BDS – Conference Facilitator Summary Memo

Pre-Application Conference

Case File: EA 18-202411

Proposal: A Pre-Application Conference to discuss 23-story mixed-use building including hotel and residential uses. The proposed height is 250' with 180,330 square feet of floor area. No on site parking is proposed. 170-180 hotel rooms and 110-120 residential units are proposed.

01 LEVEL 01 - LOBBY
SCALE: 1/16" = 1'-0"

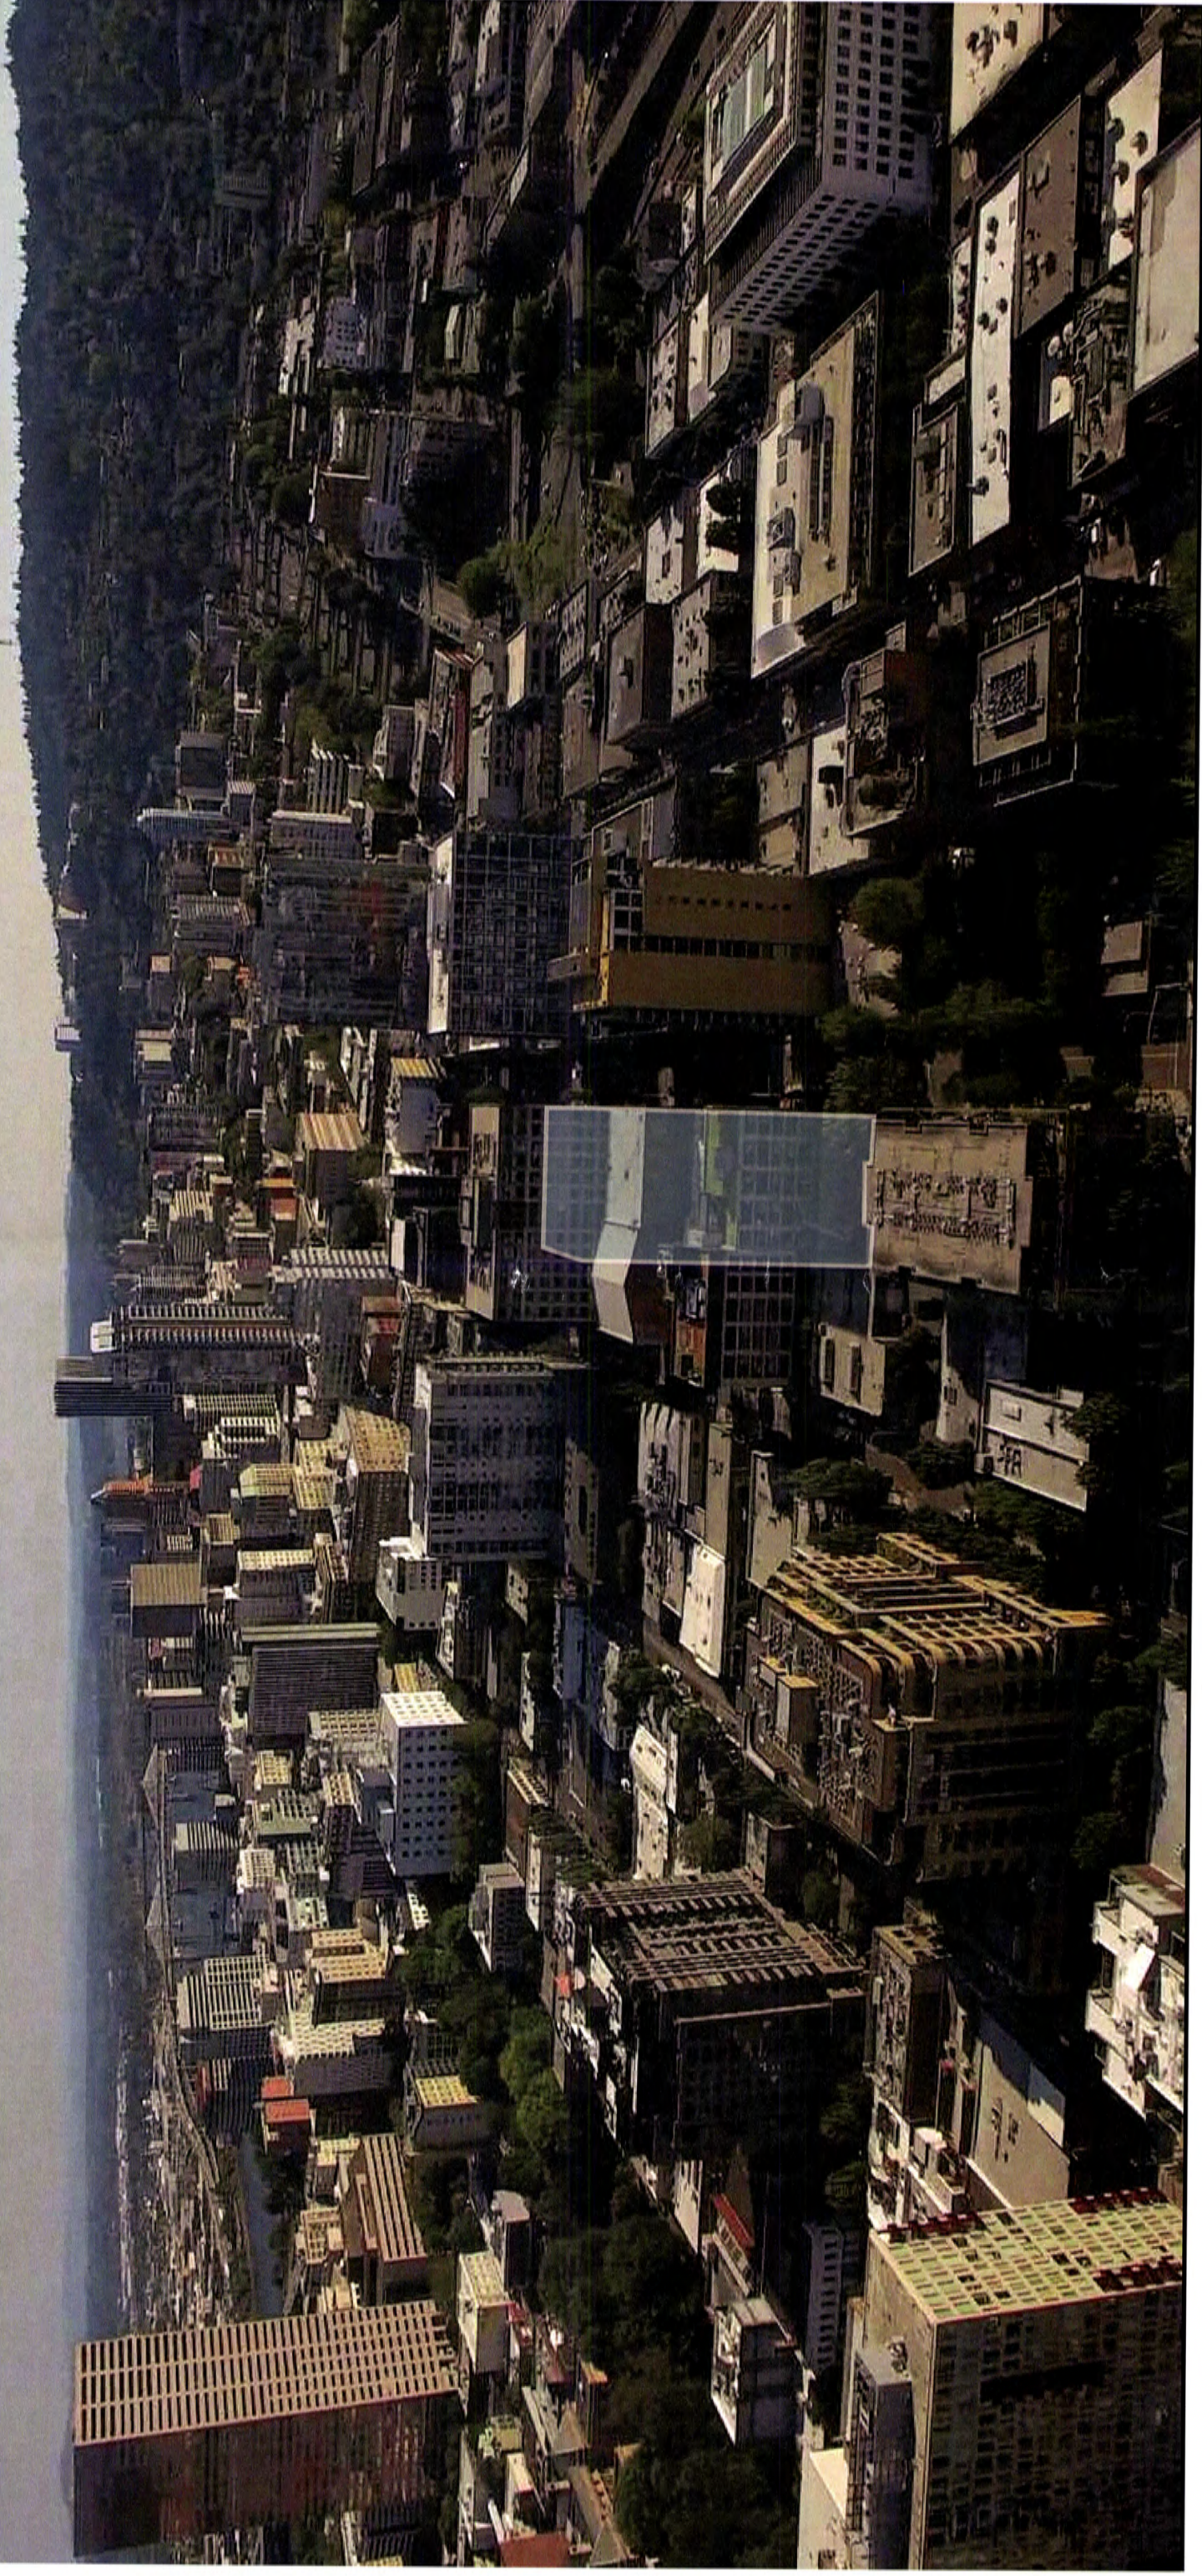
- The plan provided for the Pre-Application Conference is a good starting point for the design of an active and pedestrian-friendly public realm. The generous use

of canopies and large percentage of ground level glazing strengthens the proposal.

- As the plan develops, active uses should continue to be located around the perimeter of the building.
- Stairs should be setback from building facades to allow more room for active ground floor uses along the building's street faces.
- When possible, loading and back of house spaces should be minimized. The current configuration of loading spaces adjacent to an exit stair creates a wide section of inactive ground floor façade area. Consider options to reduce inactive ground floor façade area.

01 WEST ELEVATION
SCALE: 1/32" = 1'-0"

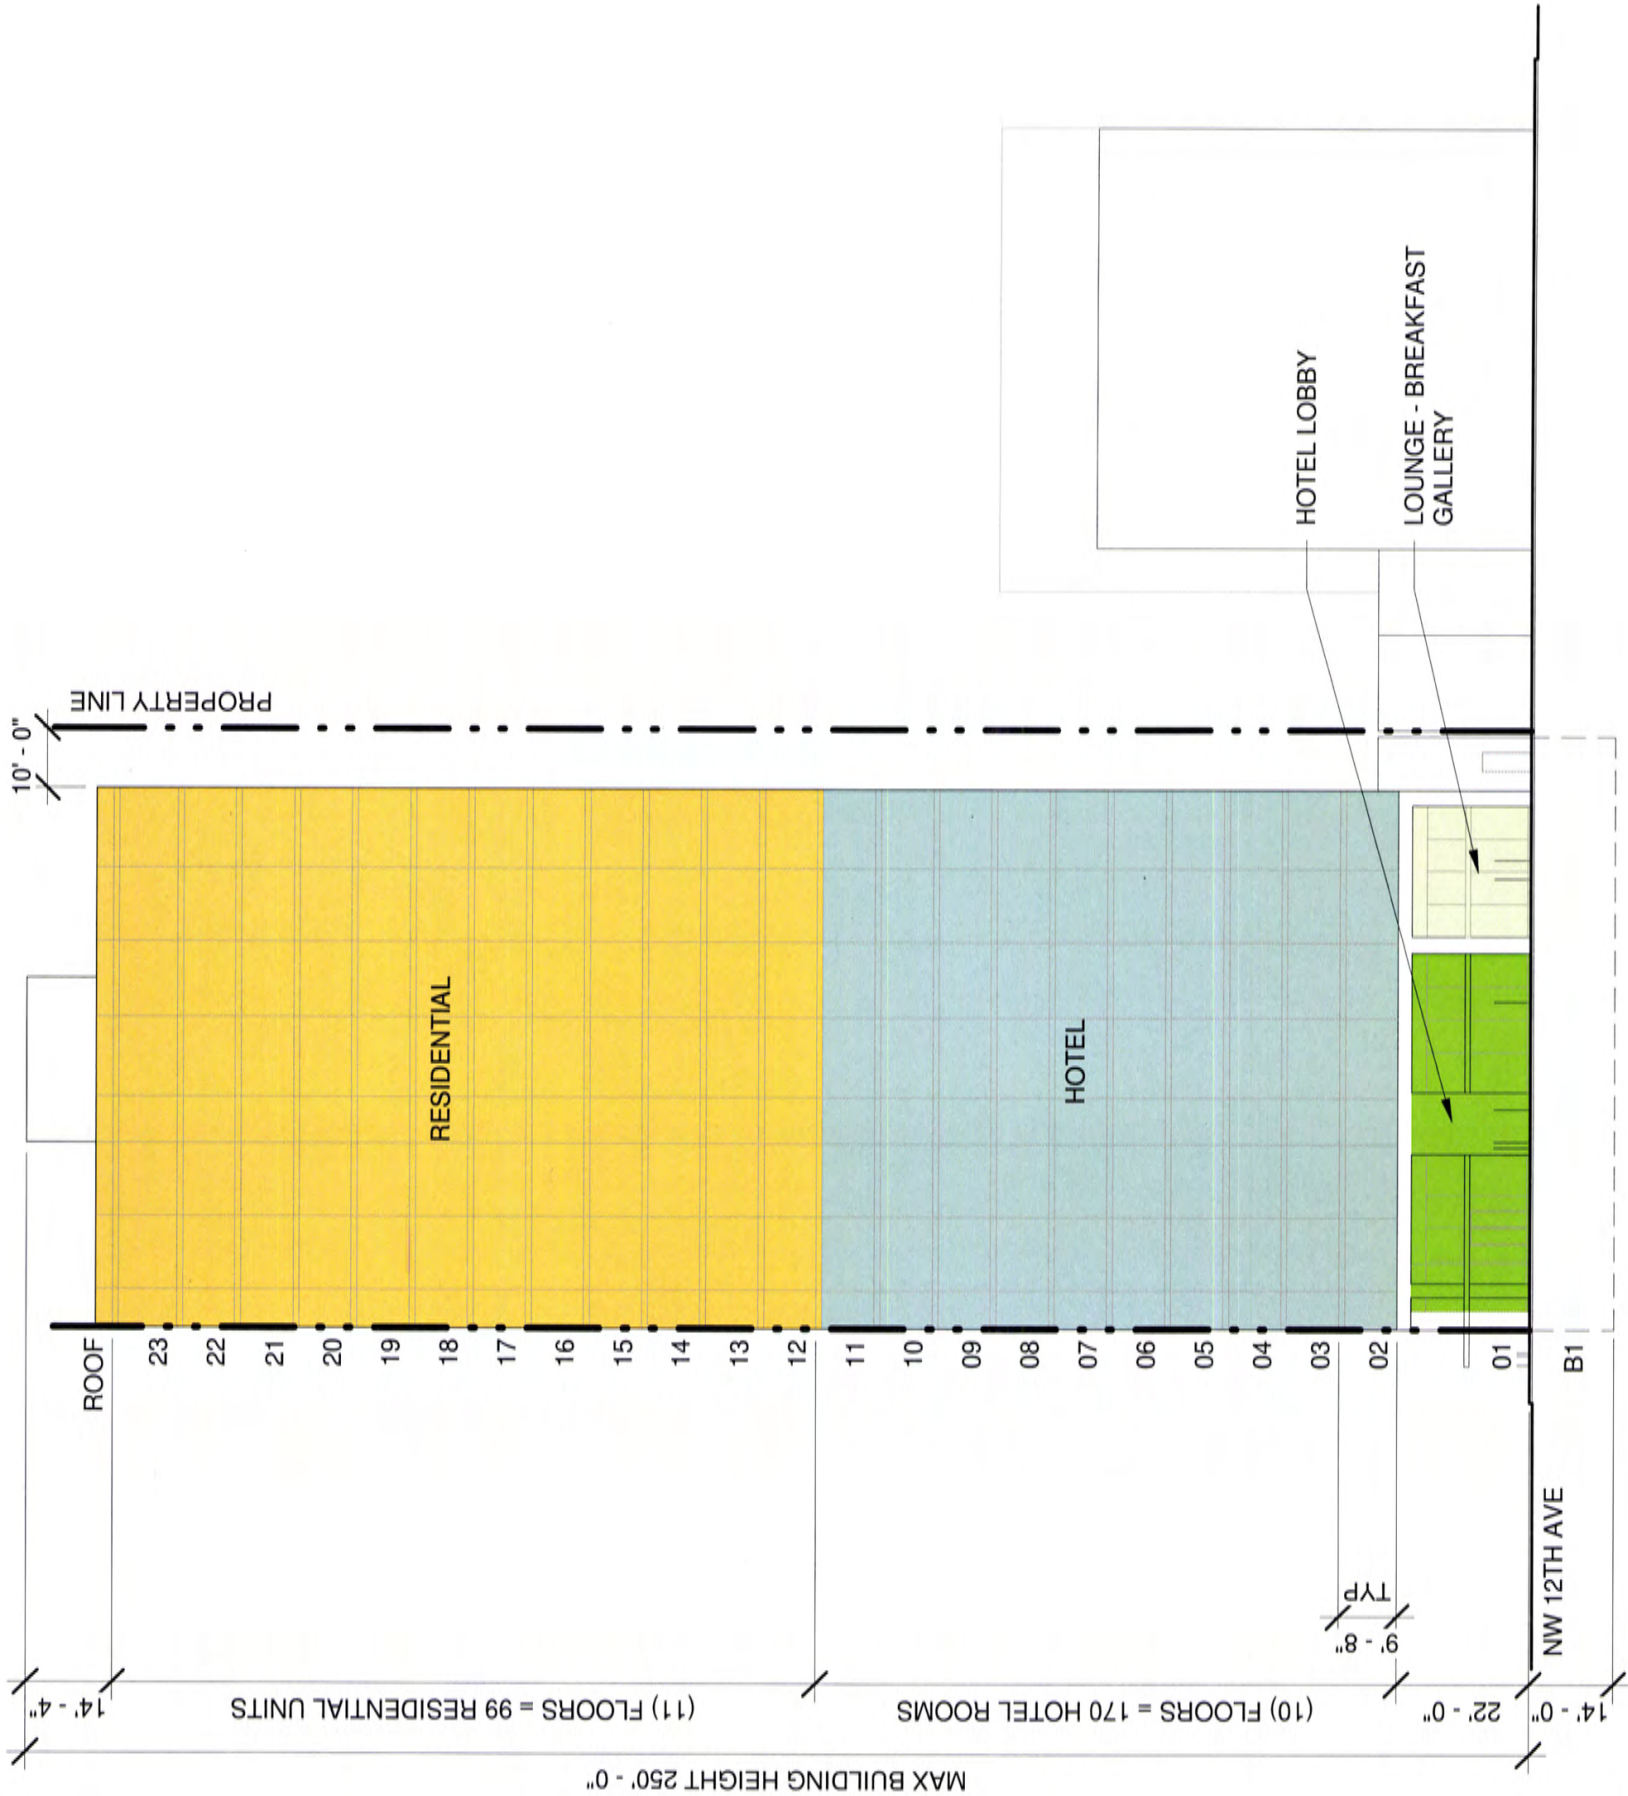
- High quality, durable materials should be planned for the building façade. Materials used should also compliment the character of the surrounding neighborhood.
- Venting through the façade should be avoided given the large number of rooms and the detrimental effect that this number of vents could have on the façade. Mechanical venting should be run vertically.
- End walls should be designed along with other elevations.
- If signage is planned, it should be designed to complement the building architecture. Note that parapet signs larger than 32 square feet may not meet the design guidelines.

- Please note that this standard has changed from that in the old Central City Plan District code chapter.
- Both street facing façades will be required to have windows that cover at least 40 percent of the ground level wall area (the area between 2 feet and 10 feet above grade).
